Town of Hilton Head Island
Design Review Board Meeting
Tuesday October 10, 2023 – 2:30 P.M.
AGENDA

Response from comments from Conceptual Review for the New Serg Brewery/Car Storage at 1014 William Hilton Parkway

FINAL DRB SET
 A RENOVATION FOR A NEW BREWERY/
 CAR STORAGE AT:
1014 WILLIAM HILTON PKWY
 HILTON HEAD ISLAND, S.C.

A.3.2
OF SHEETS

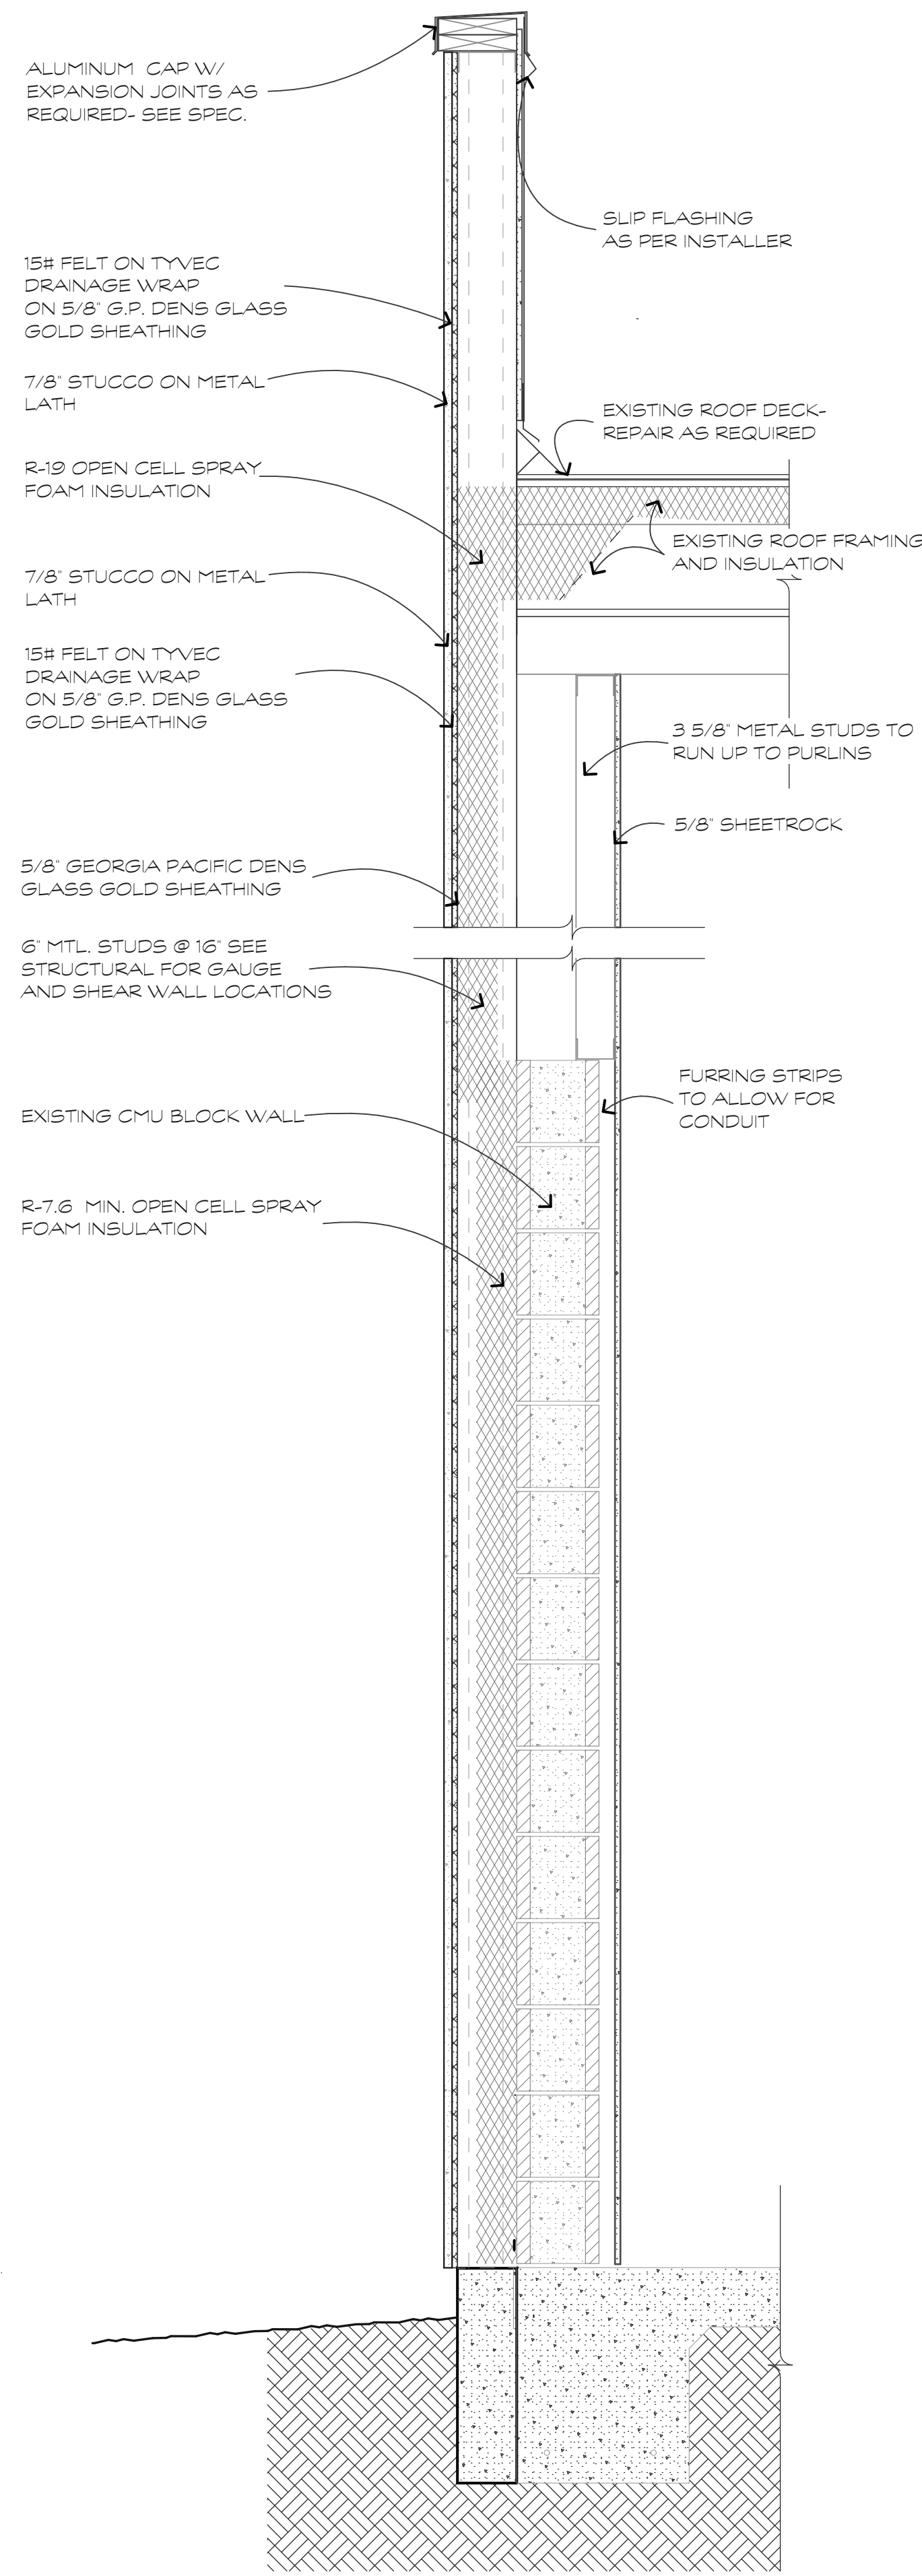
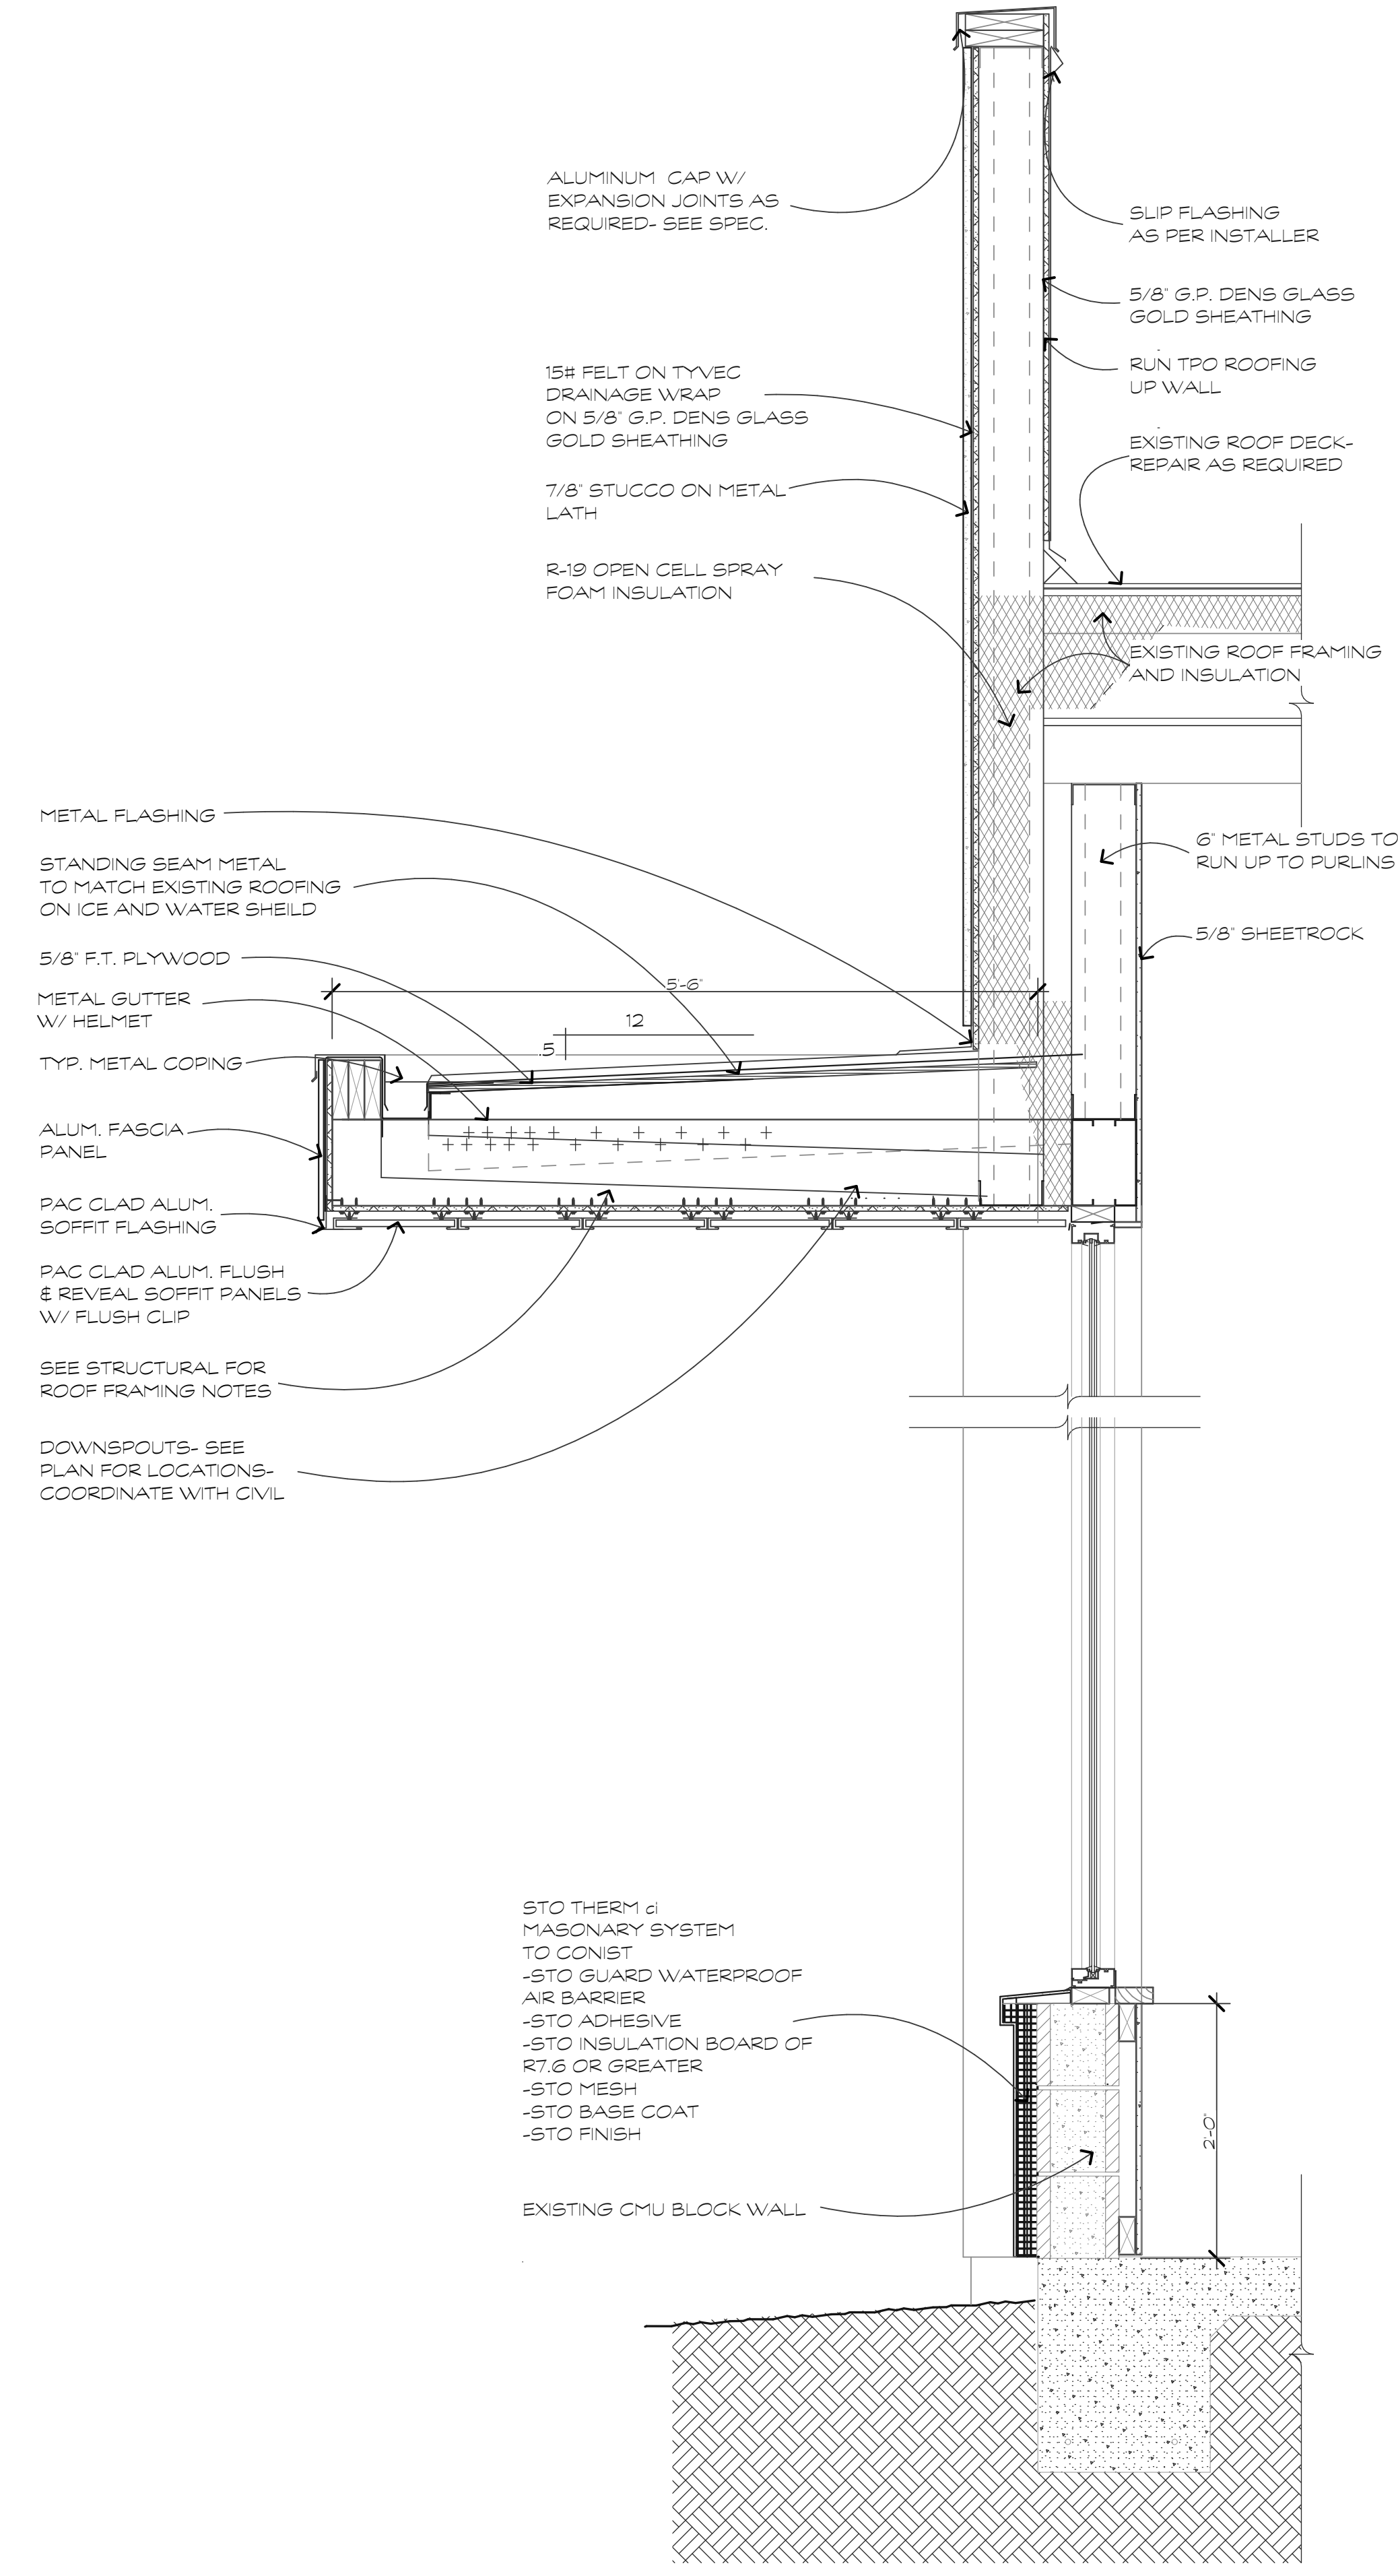
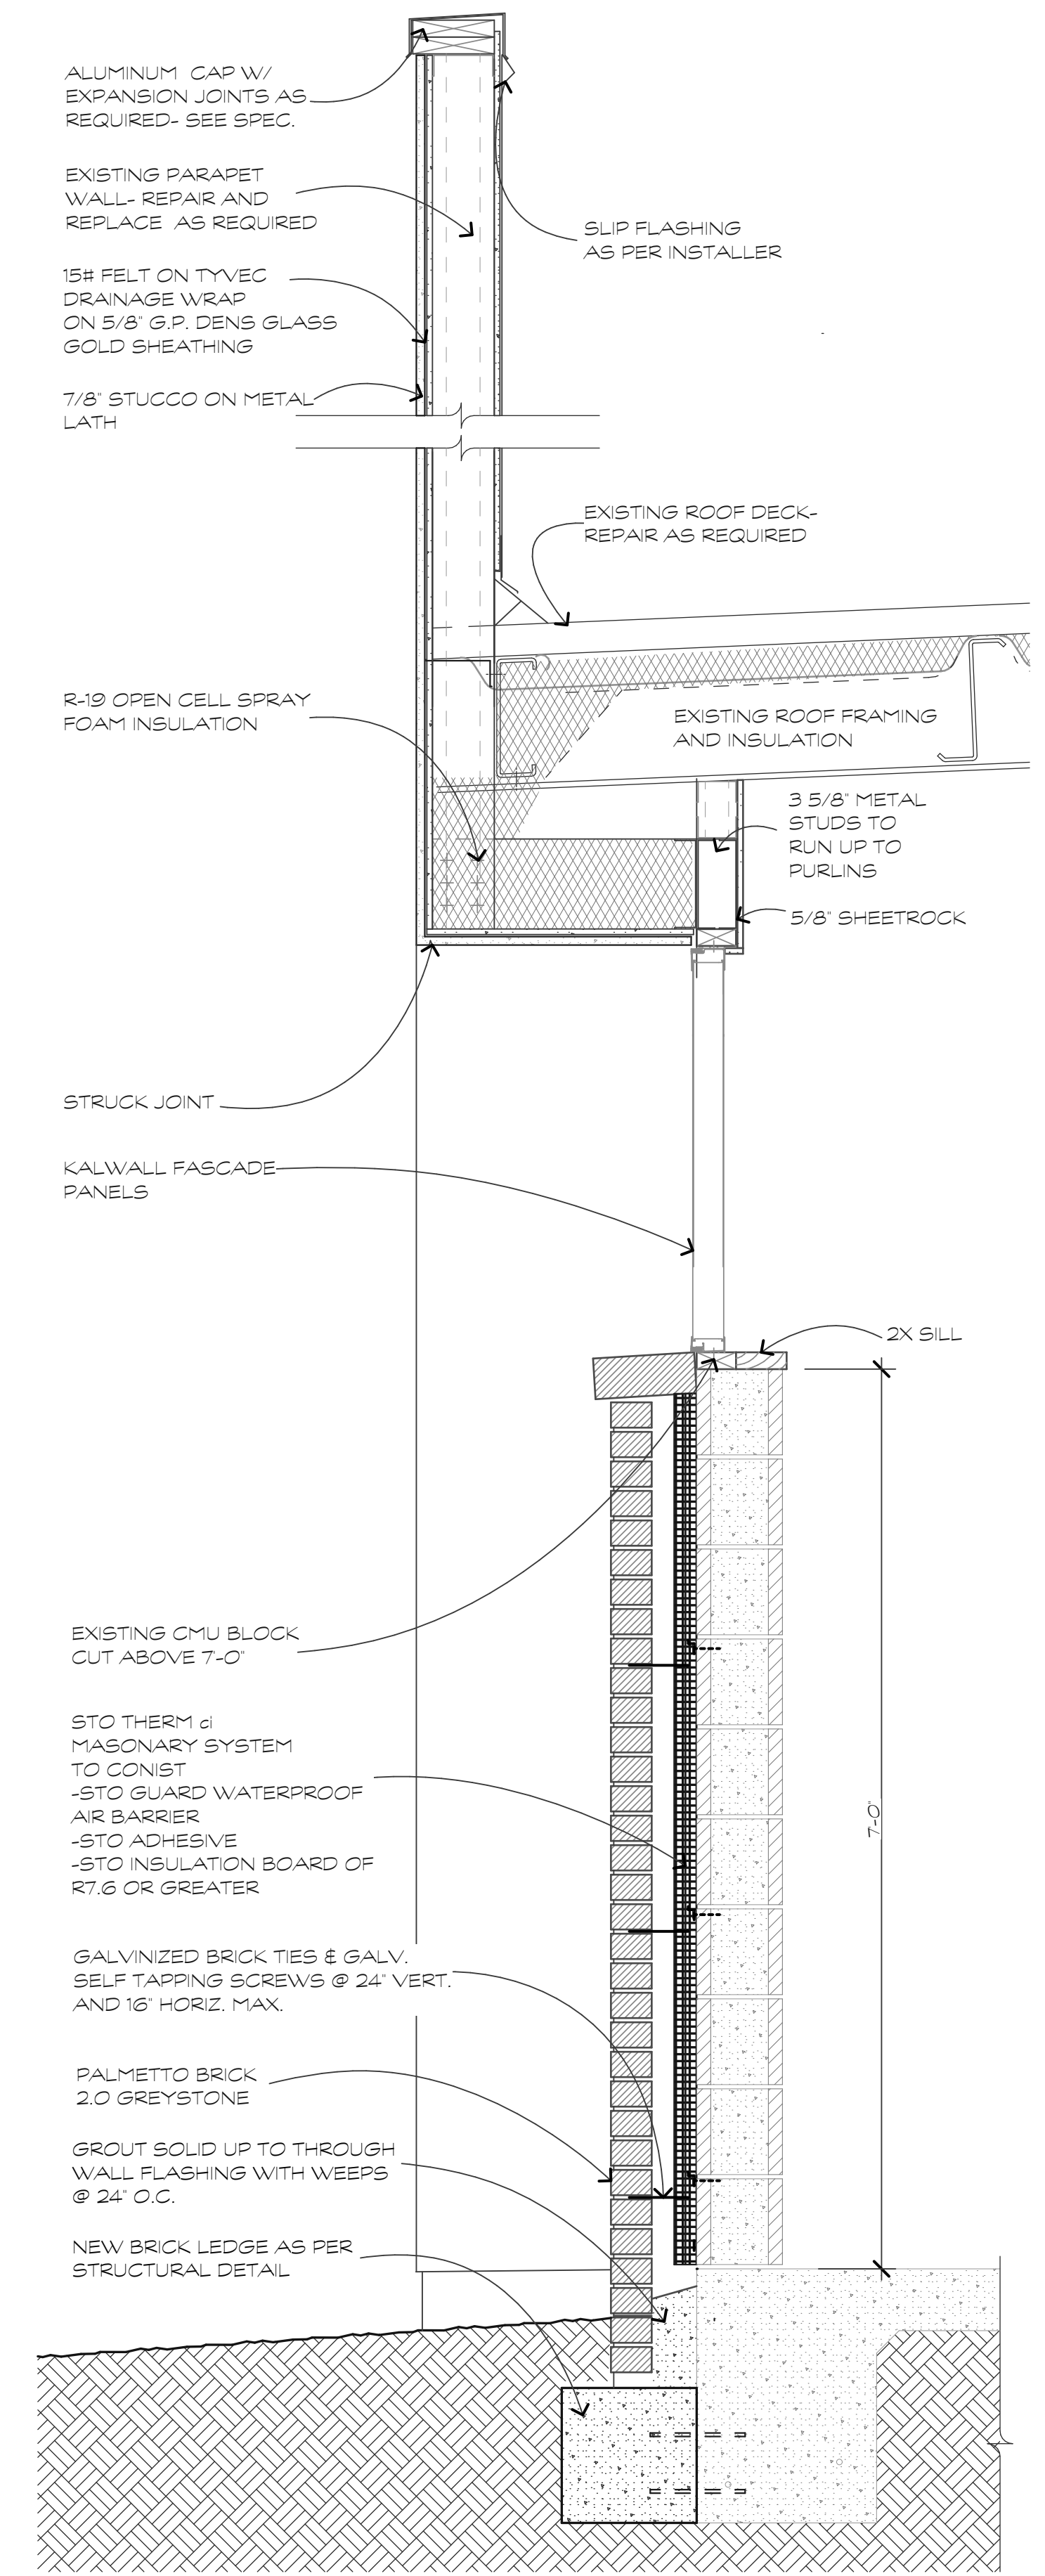
1. Correct the left and right color visual titles on the plan. ***We have corrected the left and right color visual titles on the color elevations.***
2. Add wall sections where appropriate to show dimension and scale. ***We have added wall sections to the final DRB set. See sheets A.3.1 and A.3.2.***
